LOCATION HWY 140 / CNR & CPR STRUCTURES
EMBANKMENT FAILURE

Re: Slope Flattening of Approach Embankment
Highway 140, C.N.R. Overhead Structure
W.P. 174-87-00, Site 34-232
District 4, Burlington

Subject: Instability of Approach Embankments
Highway 140, CNR Overhead Structure
W.P. 174-87-00, Site No. 34-232
District 4, Burlington

Fig 2. Slope Failure

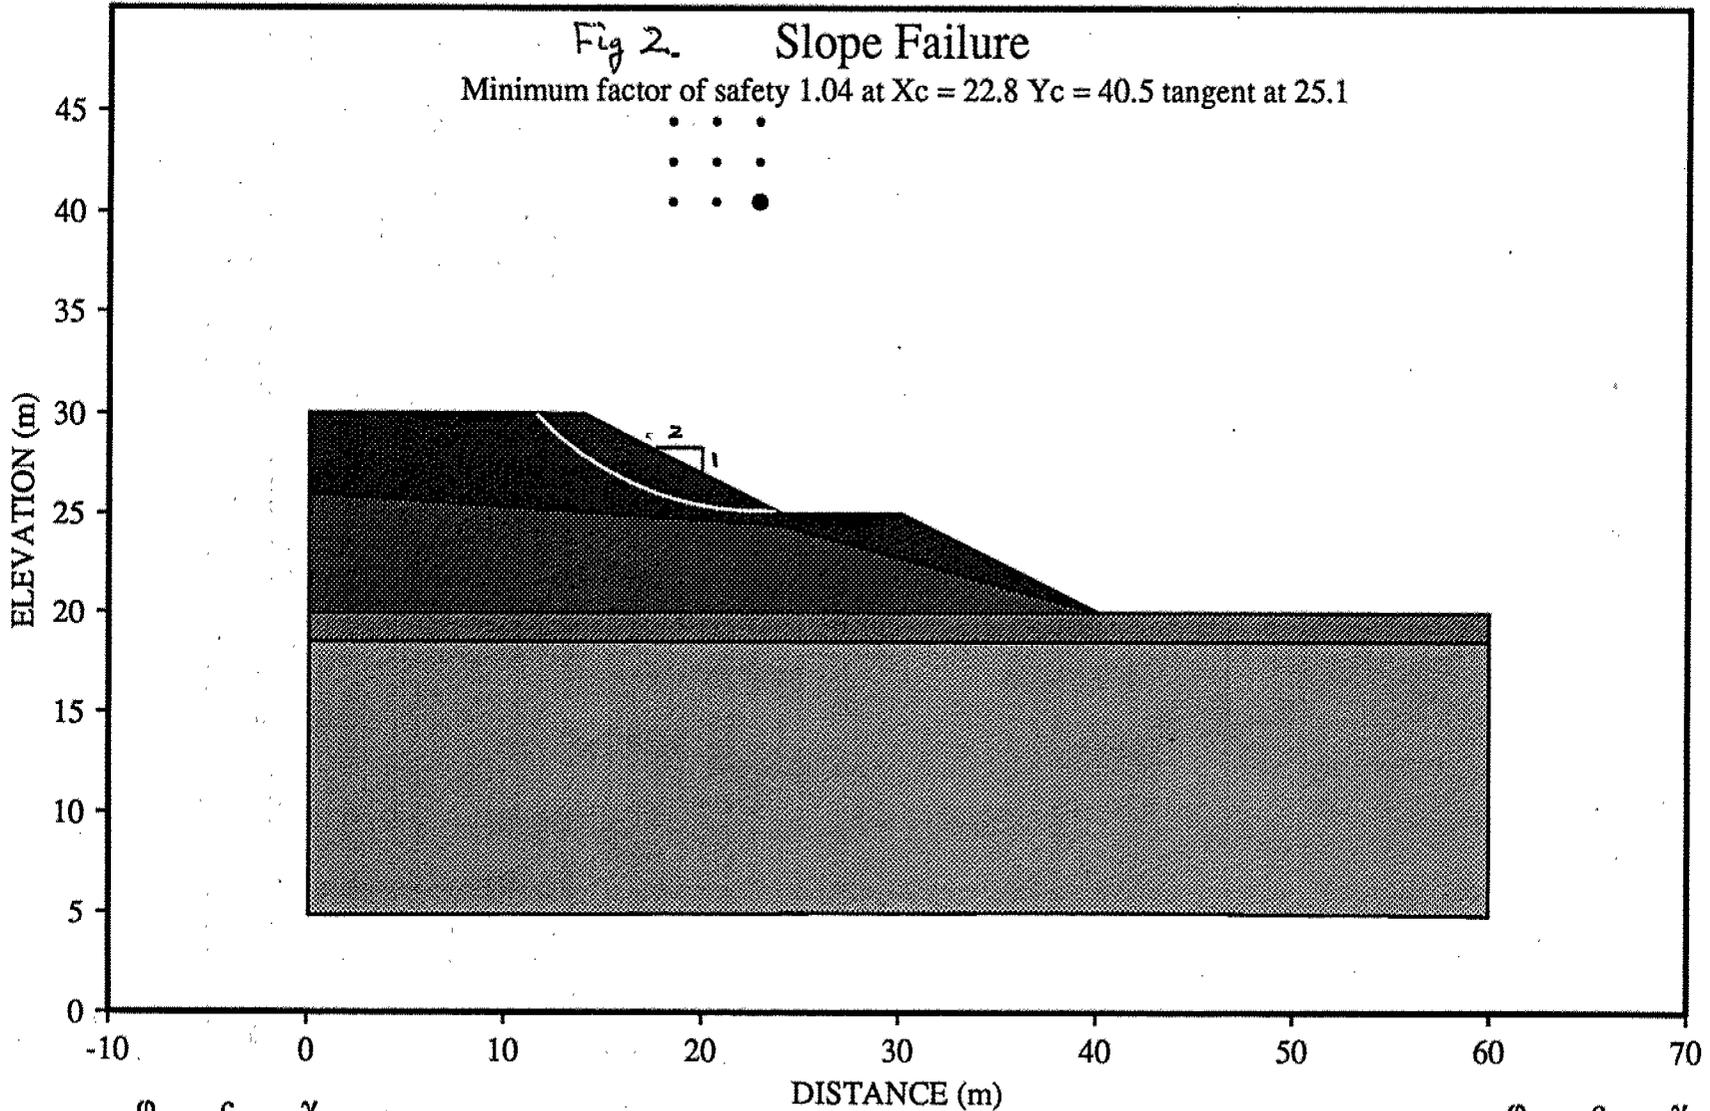
Stability analyses were carried out for different height of fill in upper silty clay slope with different side slope as shown on Figure 2. Based on the analyses as shown on Figure 3, the following conclusion have been derived for the upper slope.

Approach fills up to 2.8 m in height will be stable provided they are constructed with standard 2H:1V slopes. A flatter side slope will be required for the higher fill exceeding 2.8 m in height to ensure the stability of approach fill. The existing 5 m high fill above the mid-height berm will require a flatter slope of 2.75H:1V as shown in Figure 3.

FIG-4 . Slope Failure

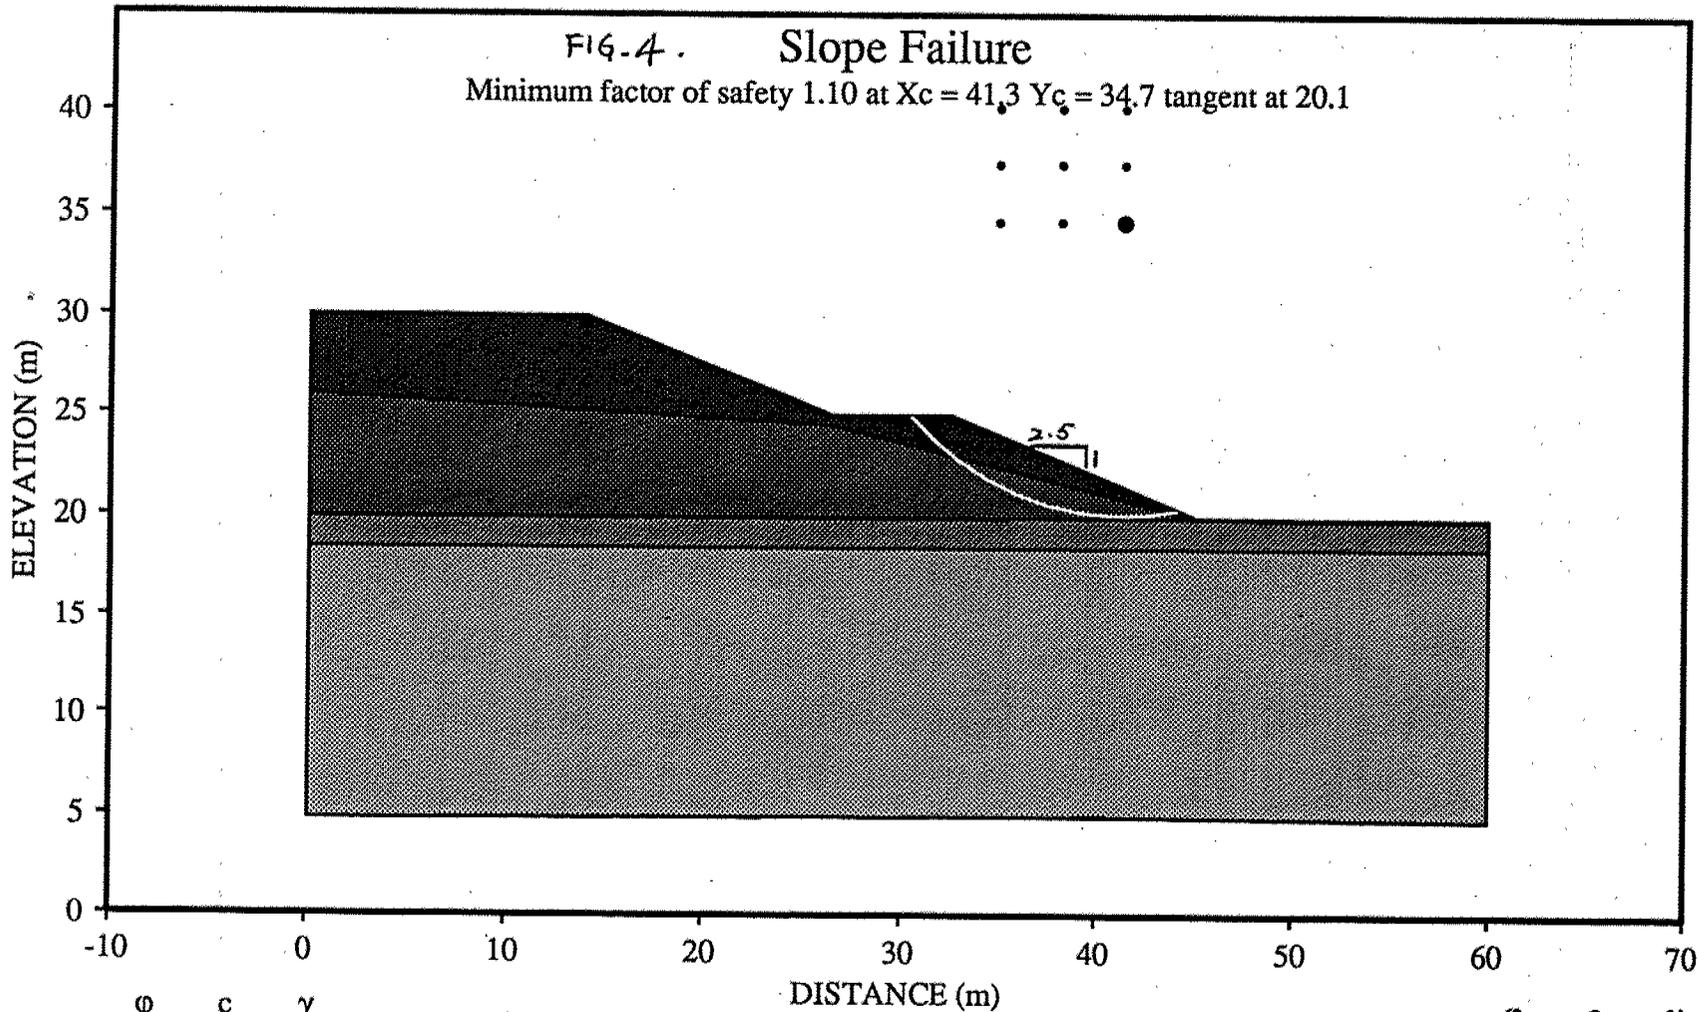
Figure 4 shows a typical section of the lower slope. Stability analyses were also carried out for different height of fill with different side slope as shown on Figure 5. It should be noted that for the existing 5 m high lower slope, a flatter side slope of 3H:1V will be required to ensure the stability as shown on Figure 5.

STABILITY ANALYSES WITH DIFFERENT SLOPE ANGLES (MINIMUM FACTOR OF SAFETY)

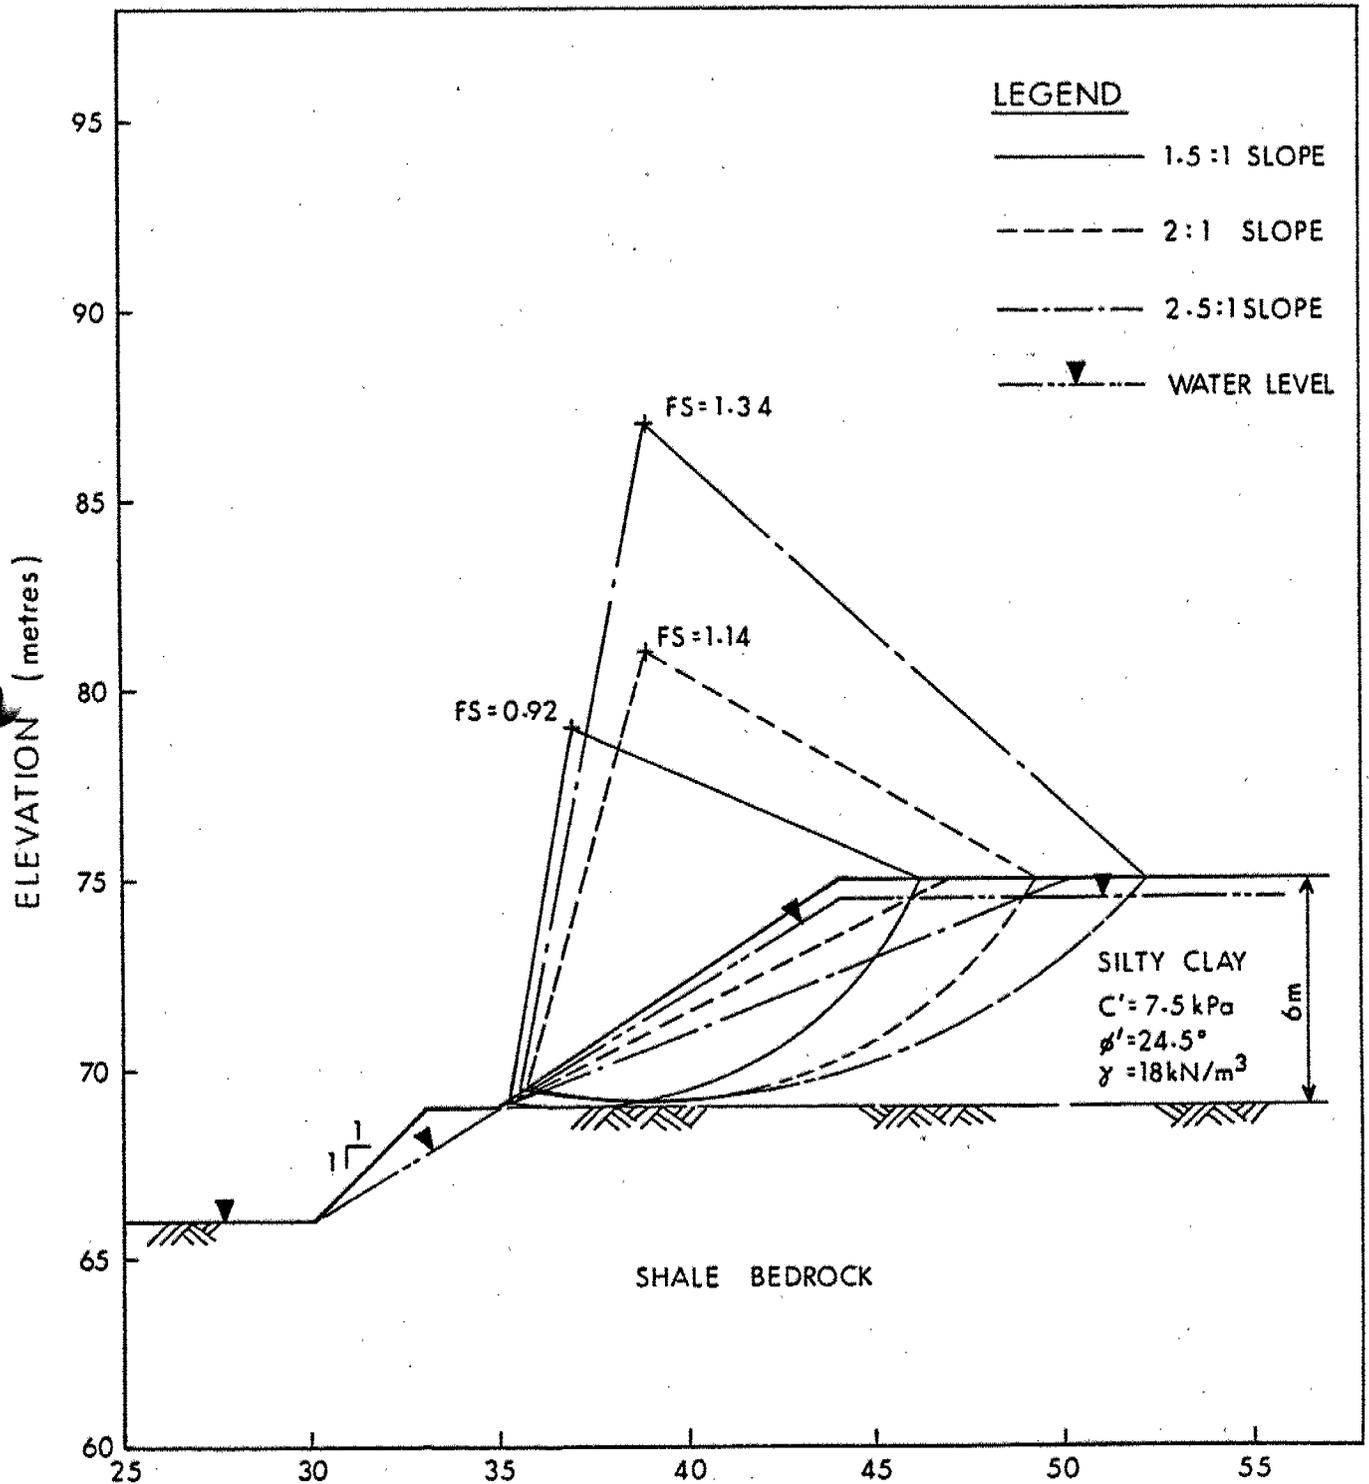
An effective stress analysis was applied for calculations of slope stabilities of the excavation cut. Since the proposed cut is only temporary during the construction of bridge structures, a minimum factor of safety of 1.2 was incorporated for the analyses. It should be noted that since the depth to bedrock is somewhat variable at the site, analyses were carried out for different depths of cut in sensitive silty clay with different side slopes as shown on Figure 1. Based on the analyses, the following conclusions have been derived:

MINIMUM FACTOR OF SAFETY VS DEPTH OF CUT

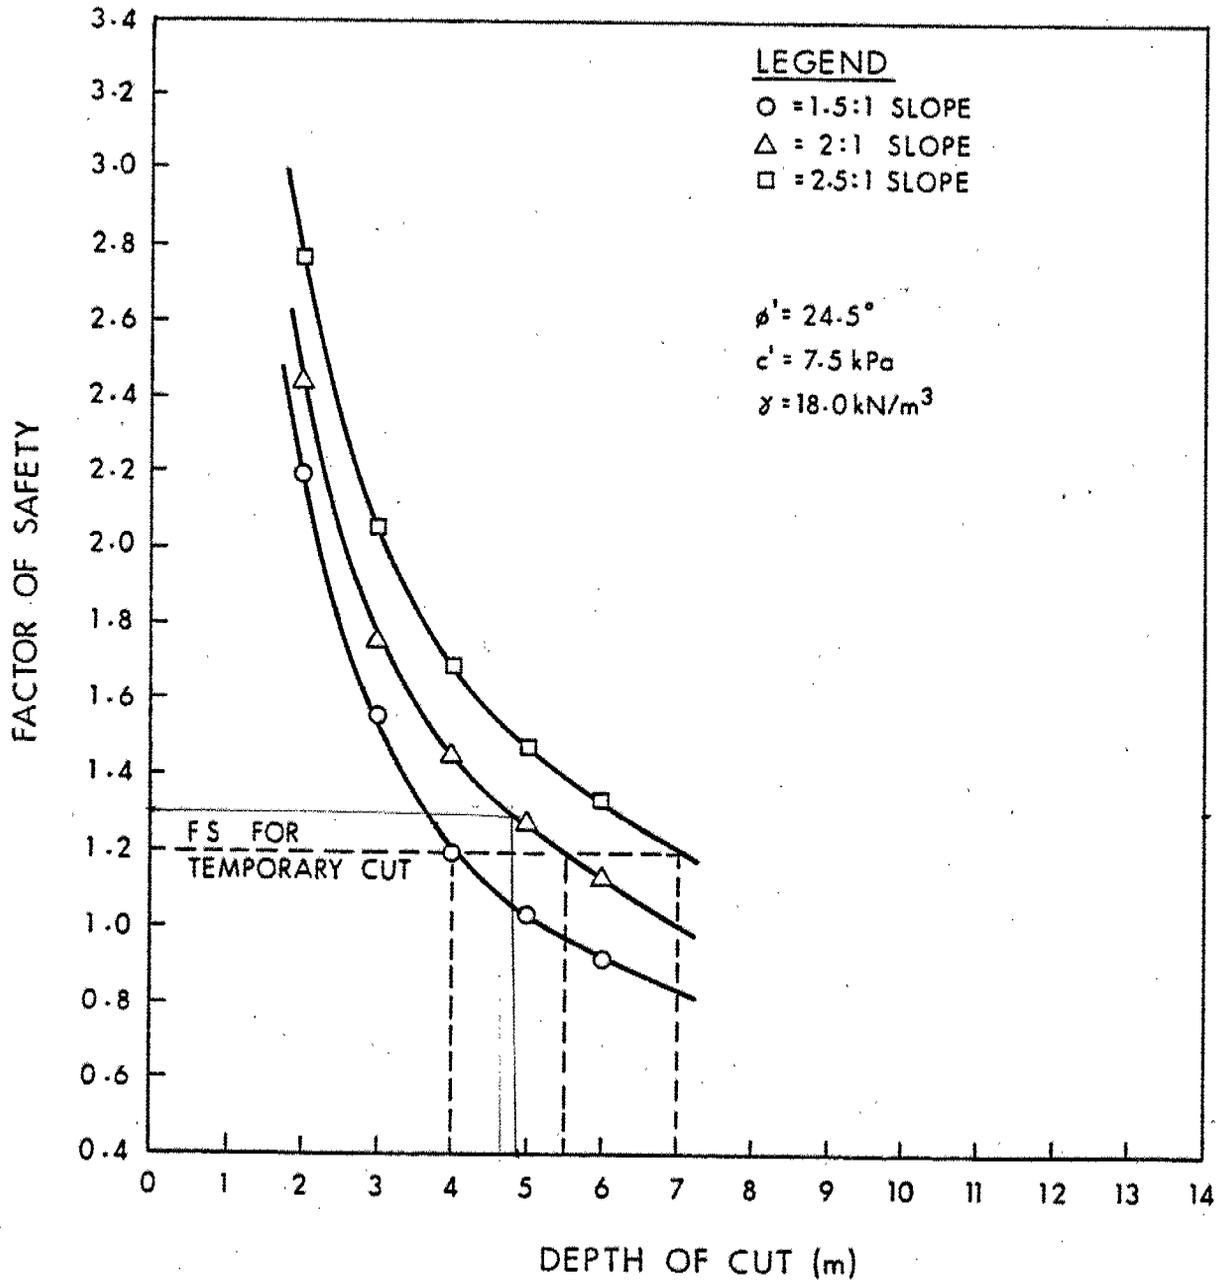
Excavations down to 4.0 metres in depth will be stable provided they are maintained with $1\frac{1}{2}$ H:1V slopes, while deeper cuts between 5.5 and 7.0 metres will require 2H:1V slopes and $2\frac{1}{2}$ H:1V slopes, respectively, as shown in Figure 2. For excavations exceeding the above-mentioned depths, nominal mid-height stabilizing benches will be required.

STABILITY ANALYSES OF DEEP CUT FOR
 CN RAILWAY TRACK WITH 2.5:1 SLOPE
 (LOWER BENCH WIDTH 5m)
 (UPPER BENCH WIDTH 10m)

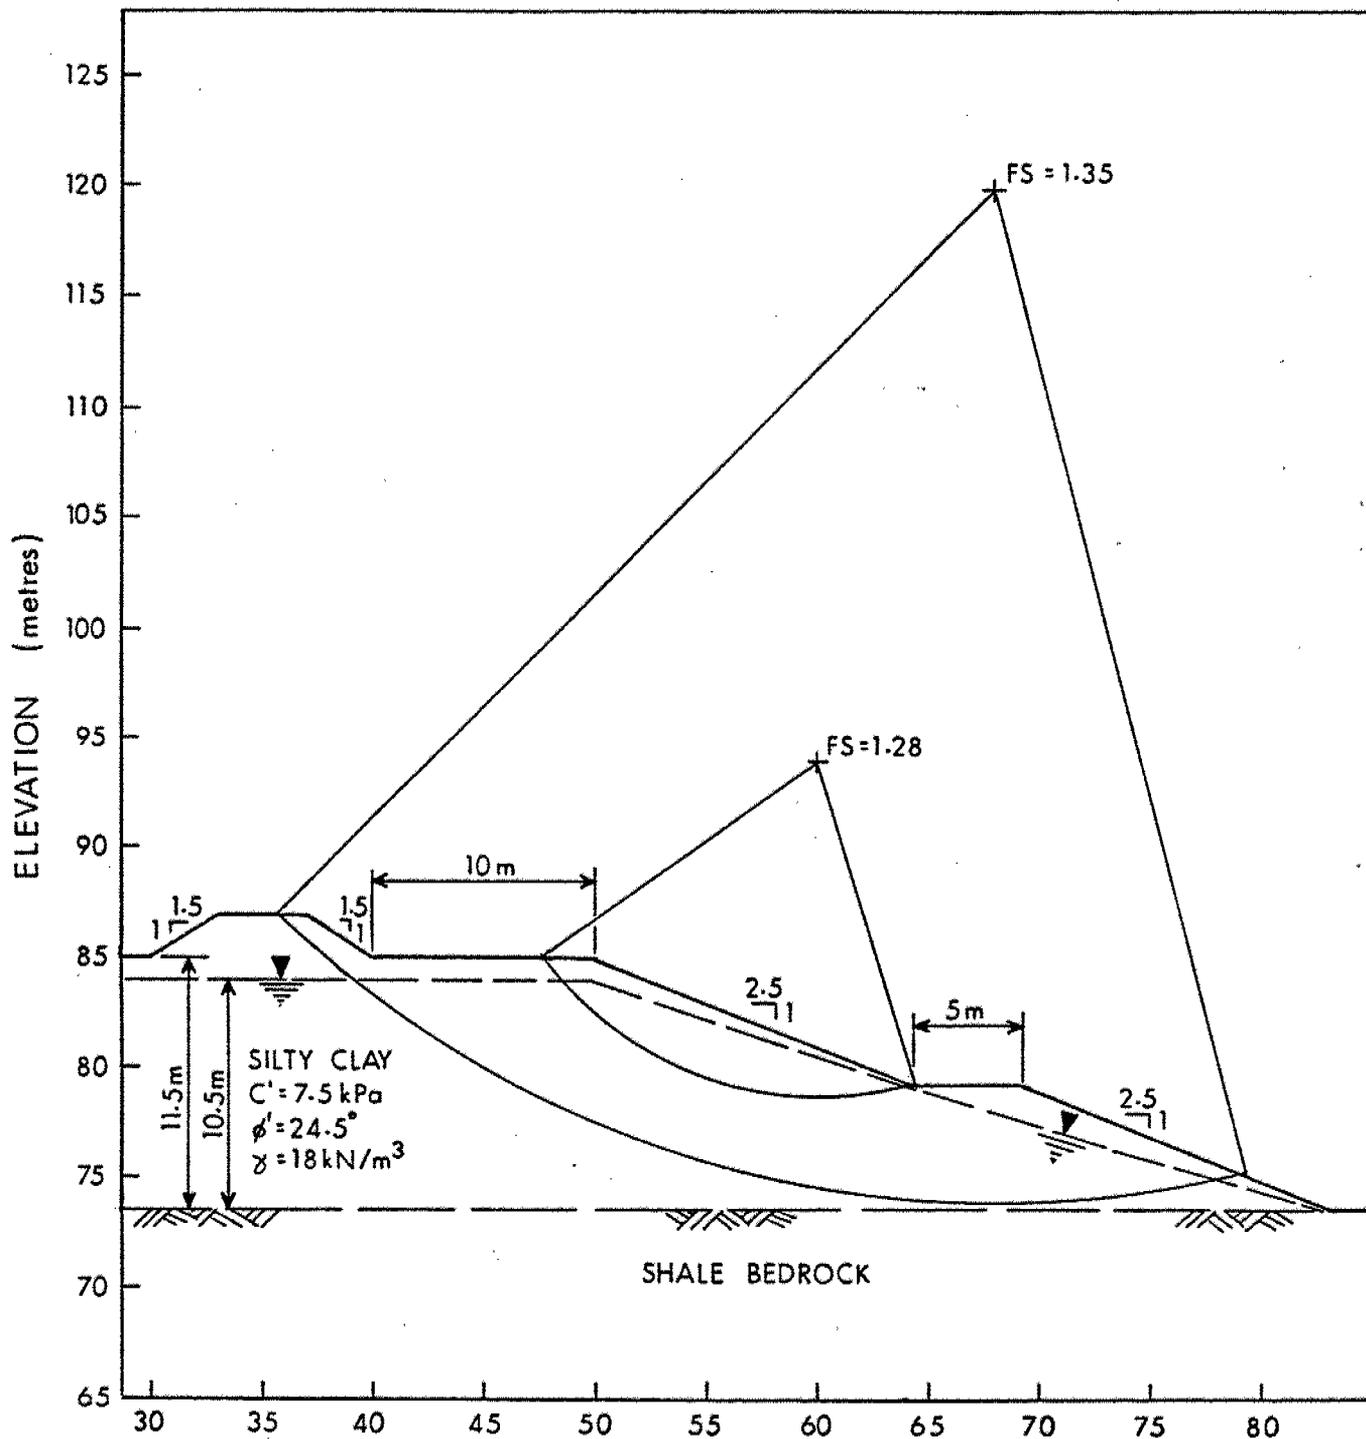
The excavations for the C.N.R. track diversion will penetrate approximately 12.0 metres into the sensitive silty clay, slope stability problems can be anticipated at this location. Based on the stability analyses, it should be noted that a 5 metre wide bench to the midheight of the slope and 2.5H:1V side slopes are required in all directions to ensure the stability of the proposed cut. In addition, a 2 m high embankment for the C.N.R. track diversion will be constructed. In order to ensure the overall stability, the embankment should be located at least 10.0 metres away from the top of the cut with $1\frac{1}{2}$ H:1V slopes as shown on Figure 3.
